**NOTICE OF DECISION TO CONSENT TO CHANGE TO PROPOSAL DURING
ASSESSMENT**

PROPOSAL TO WHICH THIS NOTICE RELATES: Asian Renewable Energy Hub –
Assessment no. 2140

STATEMENT OF REASONS

Proposal: Asian Renewable Energy Hub

Figure 3 Development envelope and indicative proposal footprint for change (ERD)

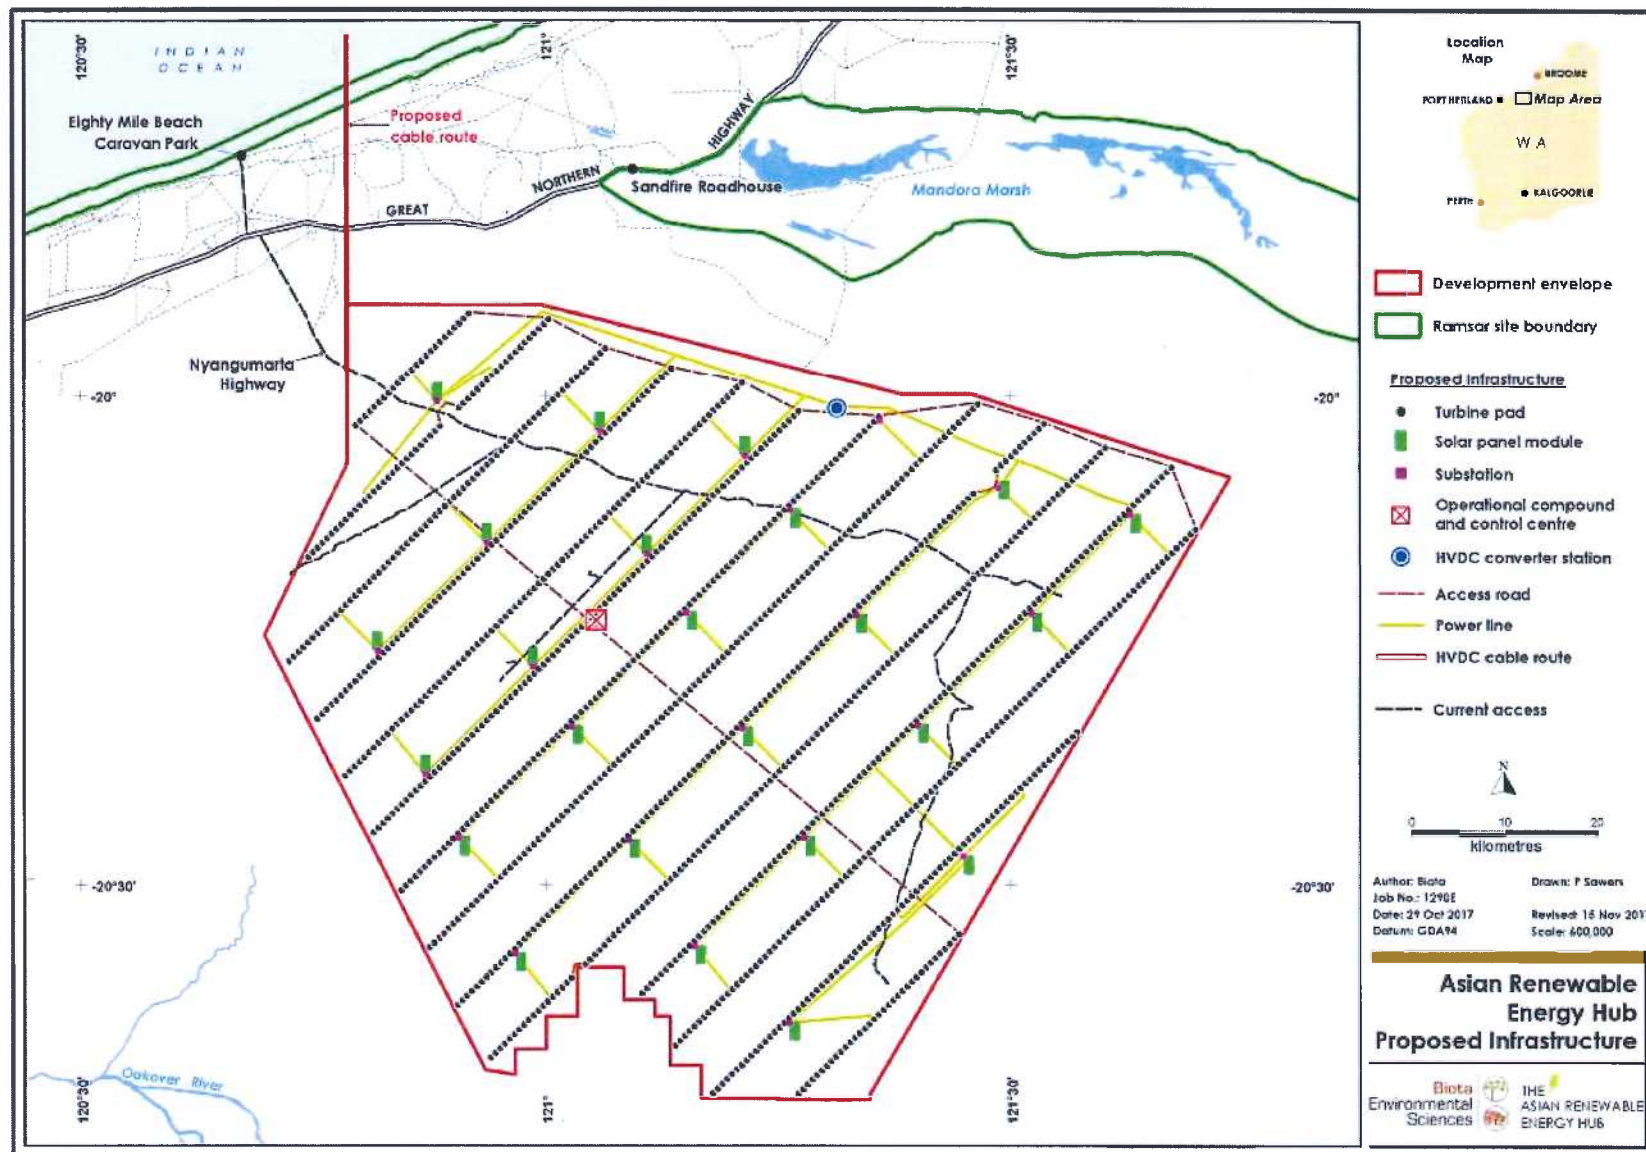
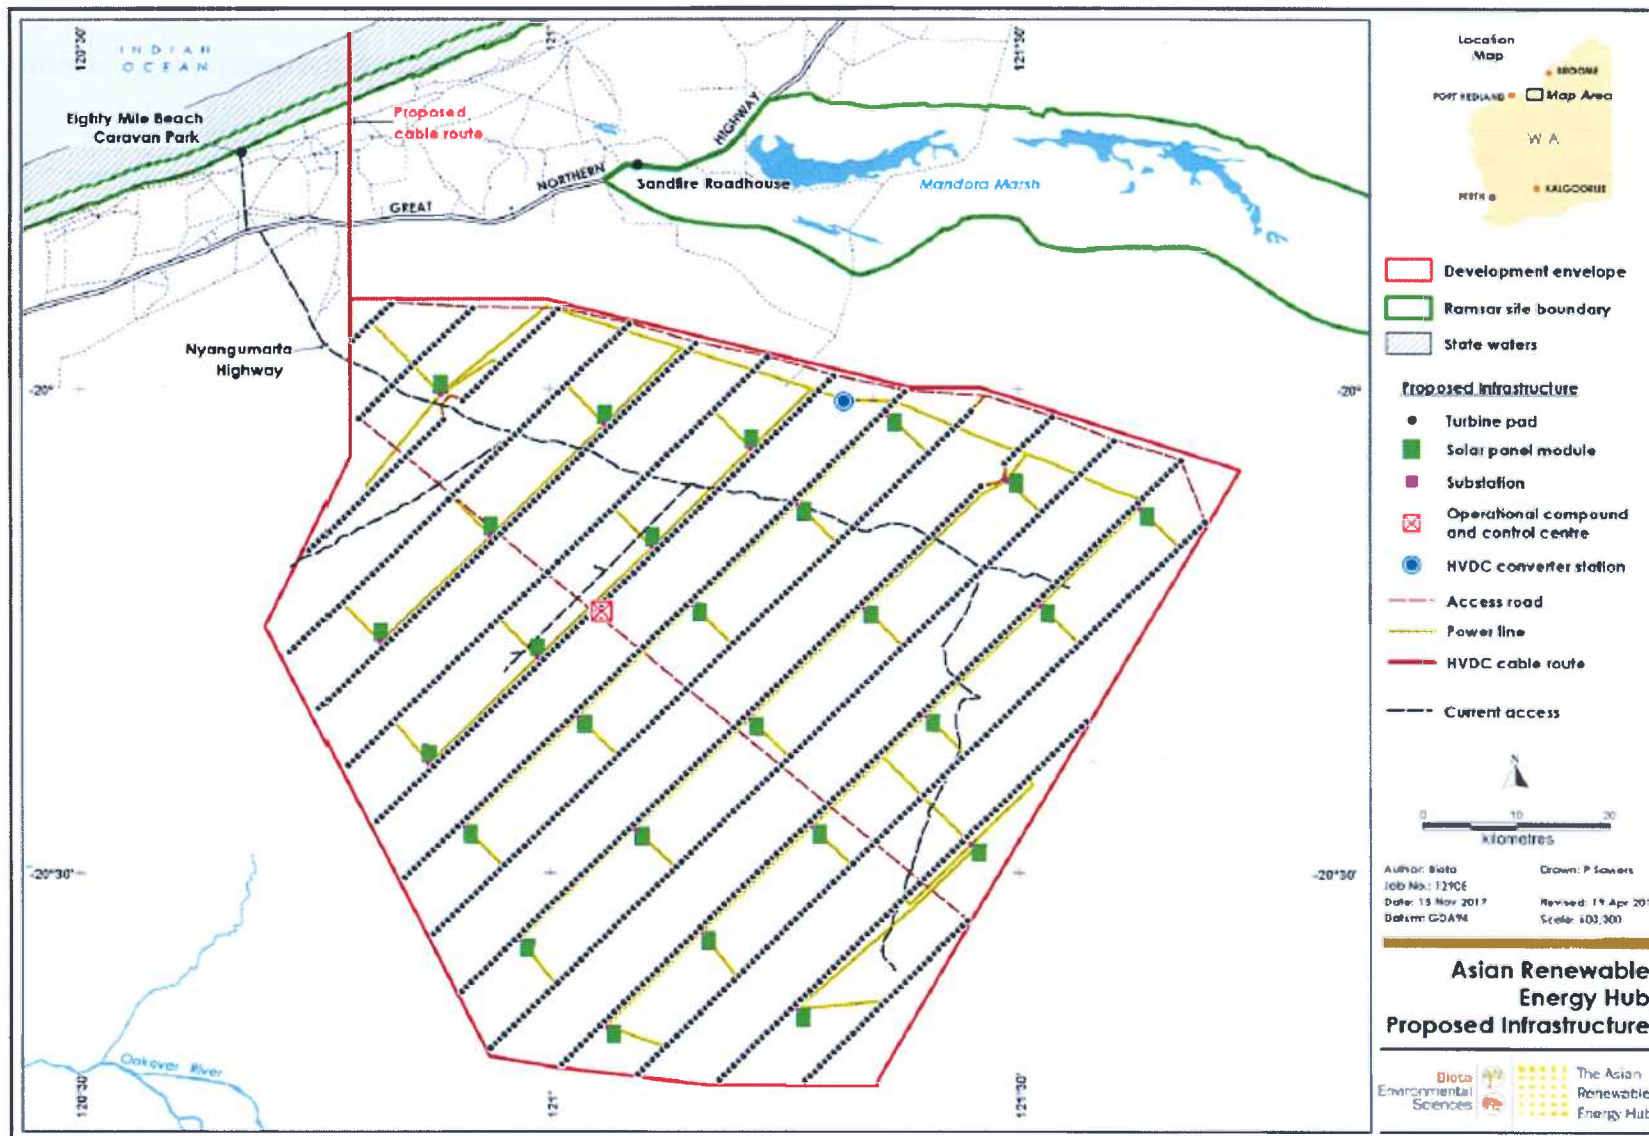
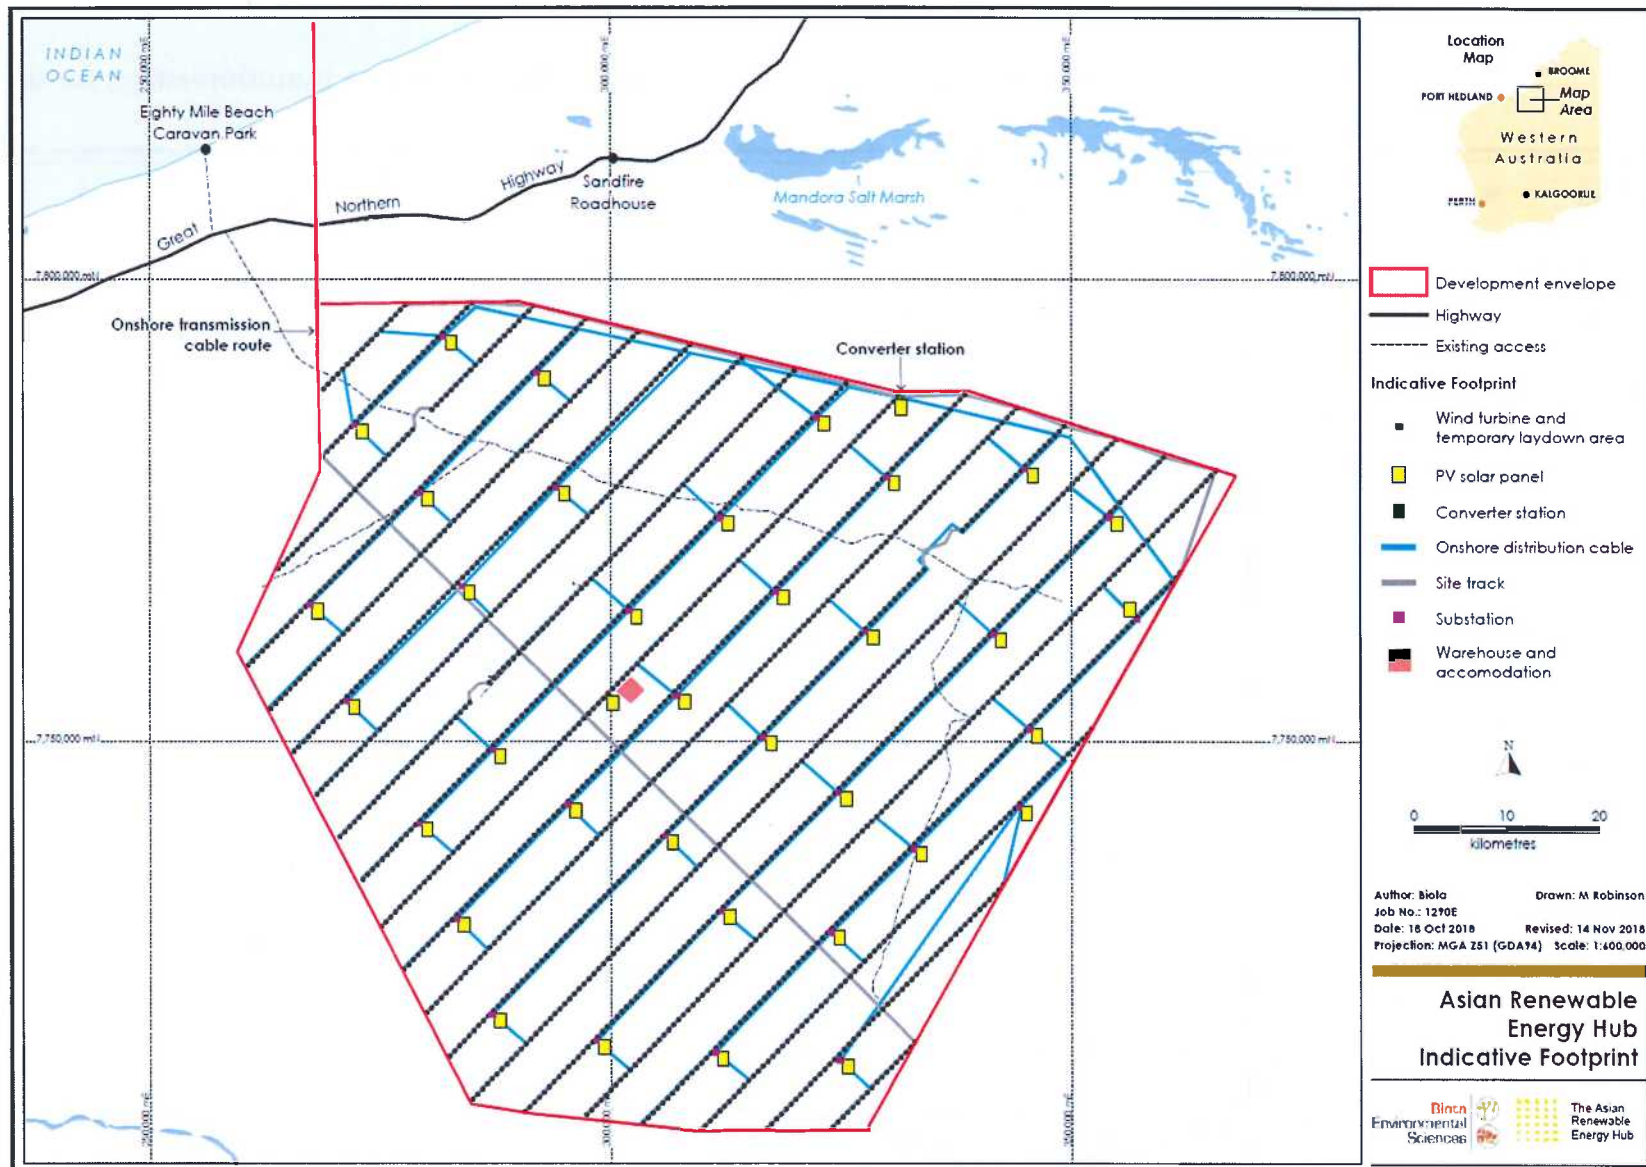
- an increase in the projects power generation;
- an increase in the extent of native vegetation clearing from 7,370 ha (at referral) to 11,962 ha;
- an increase in the number of cables exporting power from two to four (with a corresponding temporary disturbance to the sea bed from 3 ha to 15.3 ha);
- an increase in the number of wind turbines and their capacity; and
- an increase in the number of solar panel arrays and associated electrical infrastructure.

The change to the proposal involves an increase in proposed native vegetation clearing from 7,370 hectares (ha) at referral to 11,962 ha (i.e. an increase in native vegetation clearing of 4,592 ha or 62% increase). This equates to an increase of 0.7% within the entire development envelope of 644,600 ha. The changes to the proposal conceptual design have been driven by the planned increase in the project's power generation, which is a function of the recent shift in focus of the project to also supply renewable power to the Pilbara Region and the potential for other downstream developments. The proposed changes from the referral document to the approved ESD to now are outlined below in Schedule 1.

The number of export cables will be increased from two to four. This increases the direct impact on the sea bed from 3 ha to 15.3 ha. This change is not considered significant as:
